# 66102A-08

## S E R V I C E N O T E

### 66102A DC Power Supply

**The instrument will not communicate or will not complete self test.**

**Figure1**

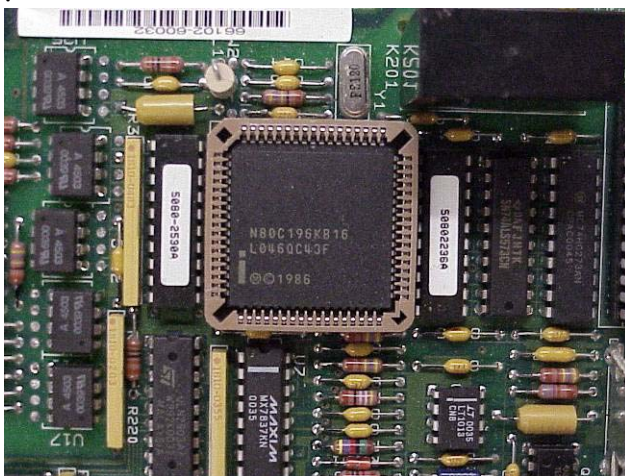
Figure 1 will help to identify the **68-PIN PLCC SOCKET location** - P/N 1200-1274 (Circuit Reference “U001”)

Any Model having a serial number starting and ending with the serial numbers shown in the chart below should have the socket 68-PIN PLCC SOCKET - P/N 1200-1274 (Circuit Reference "U001") **REPLACED!**

**Figure 2**

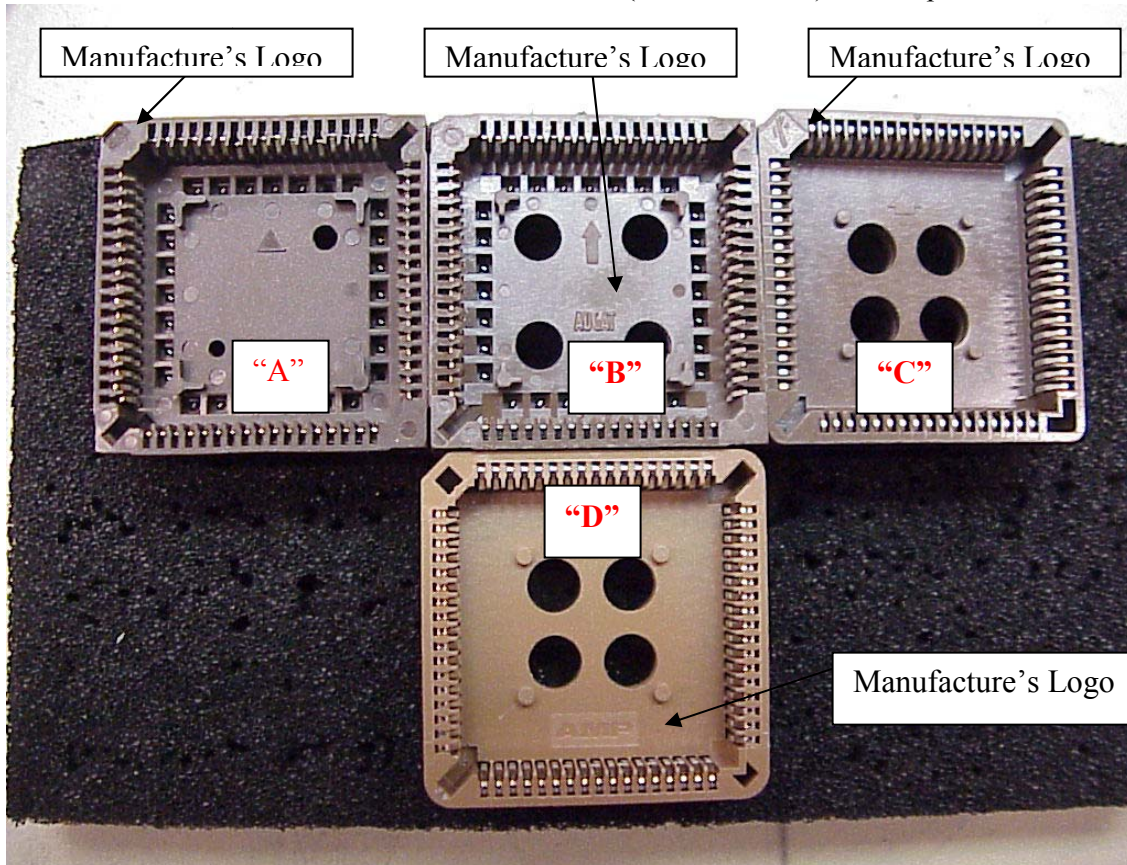
This figure should be used to identify **GOOD** sockets and a potential defective socket. The **16-Bit MCU 16 MHZ 68PLCC CMOS IC** (P/N 1821-1479) is **NOT** pictured.

- Socket **"A"** is a sample of a GOOD AMP socket.
- Socket **"B"** is a sample of a GOOD Tyco/Augit socket.
- Socket **"C"** is a sample of a GOOD FCI socket.
- Socket **"D"** is a sample of a DEFECTIVE Tyco socket.

The sockets above labeled **"A", "B" or "C"** are good and should NOT be replaced. The socket above labeled **"D"** is considered defective should be replaced.

**Discipline A – Permanent Corrective Action Plan “The socket shown in the pictures are for reference ONLY”**

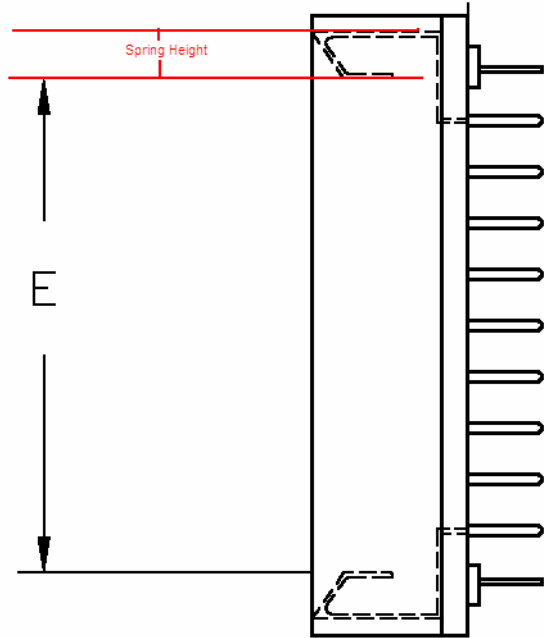
The condition of the recessed beams has been corrected by a design enhancement implemented in production. This design enhancement increased the spring height dimension by 0.04mm and decreased the spring height tolerance by 40%. The spring height dimension is shown in the drawing below.

This design enhancement is intended to position the contact beams closer to the middle of the socket and increase the normal force exerted on the contacts of the chips mated to the socket.

**Discipline B – Verification of Corrective Action “The socket shown in the pictures are for reference ONLY”**

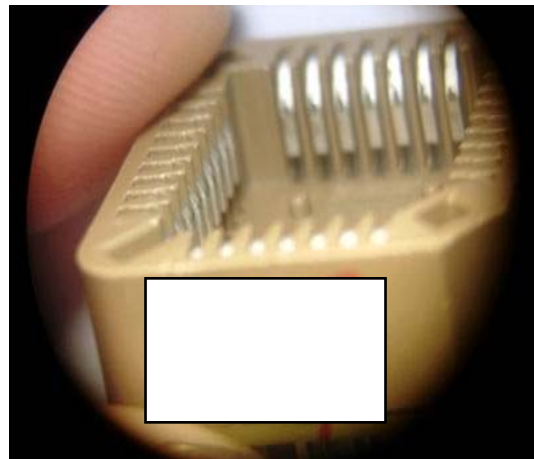
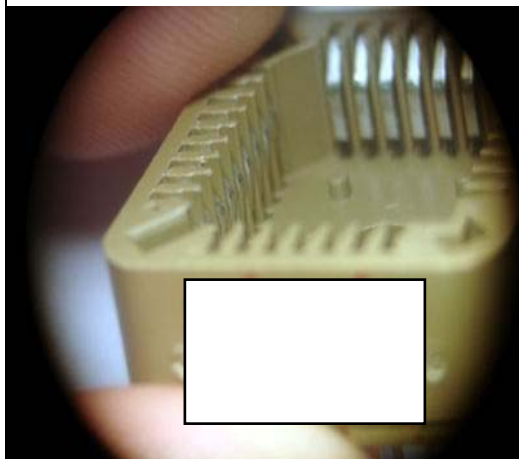
The effectiveness of this design enhancement was tested by comparing the mating and un-mating forces on the older and newer designs. The test results for sockets with the increased spring height (newer design) showed an increase in the mean mating force of 18.9% and an increase in the mean un-mating force of 23.4%. The increase in the un-mating force test results between the old design and the new design indicate that a greater normal force is being exerted on the test chip contacts by the socket contact beams. The two revisions of this contact beam design were visually examined after the mating and un-mating force testing. Photos of the two sockets are shown below. The photo on the left shows the older version socket prior to the enhanced contact beam design. The photo on the right shows a socket with the design enhancement. The contacts with the older design appear to be recessed farther into the housing after un-mating.

Material with this design enhancement will be labeled with a 2007 date code
